We would like to thank you for your comments/suggestions and the reviewers' comments you forwarded on our manuscript "Spatial spin-up of precipitation in limited-area convection-permitting simulations over North America using the CRCM6/GEM5.0 model".

Answer to reviewer 1

Answer to reviewer 2

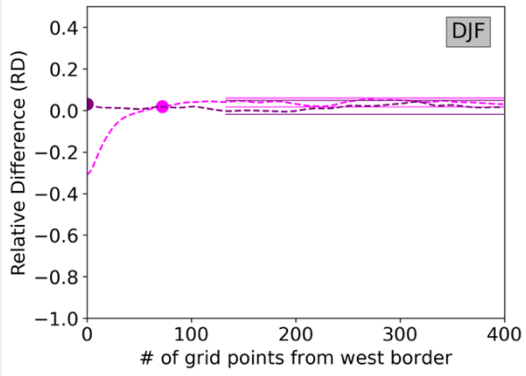
Figures 4 and 5 – consider whether you can differentiate more clearly between the two GEM2.5 configurations shown. Particularly in Fig. 5 as for the solid horizontal lines showing the standard deviation of the relative difference are hard to see which line refers to which model.

Thanks for this suggestion. We have modified the layout of the data by using a shaded colored area around the relative difference RD (see left in the attached document). We believe it is now easier to differentiate among the two simulations.
